Recall Service Bulletin RSB22-330-001

APPLIES TO: This service bulletin applies to certain 2022 model year, Gladiator and Metro Star model emergency response vehicles built between November 2021 and February 2022.

NHTSA/TC Id: 22V682

CONDITION: Certain trucks equipped with front wheel park brake and the Hendrickson NXT front suspension may be plumbed incorrectly, resulting in a non-functional front park brake.

Figure 3.1 Correct Plumbing

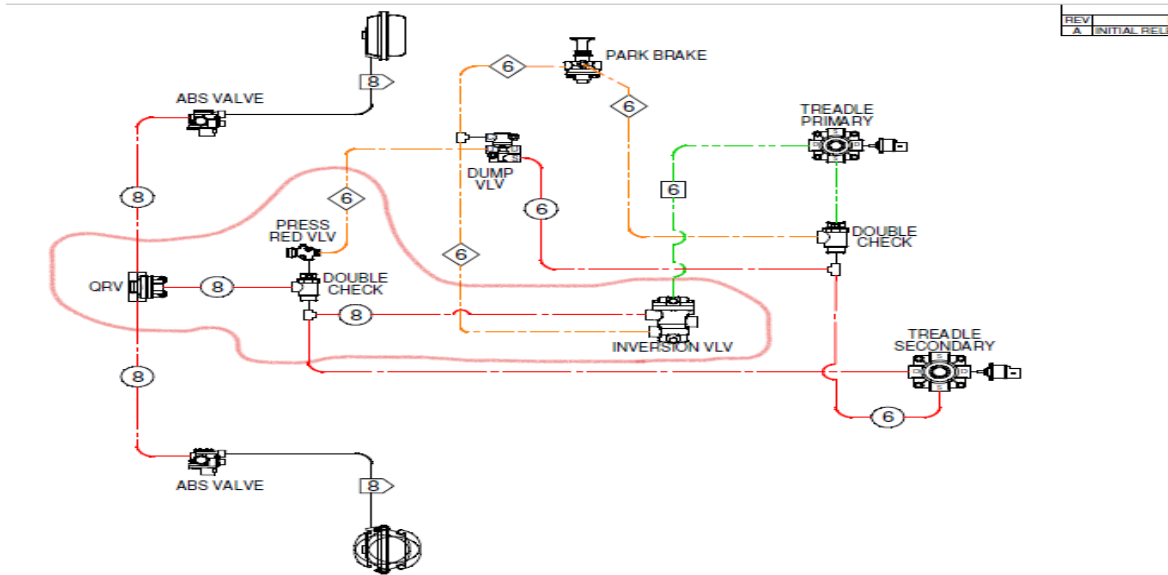
2) Inspect plumbing under front of truck to verify it is plumbed according to the Figure 3.1 and Figure 3.2

- a. The size 8 line that comes out of the side of the double check valve should go to the quick release valve.
- b. The two size 8 lines that come out of the tee out of the end of the double check should go to the inversion valve and the treadle secondary valve.

- 5) **Repair:** Once it has been confirmed that the front park brake system has not been plumbed correctly, the plumbing will need to be corrected.
 - a. Switch the 2 size 8 lines at the double check valve as shown in Figure 3.2.

- b. Trace the lines and ensure they are plumbed in accordance with Figure 3.1.
 - c. Repeat the test outlined in step 1 to validate the correct plumbing through the use of the ABS modulator self-test. If air chuffing is heard on the front modulators only during master/ignition activation, then the system is now plumbed correctly.
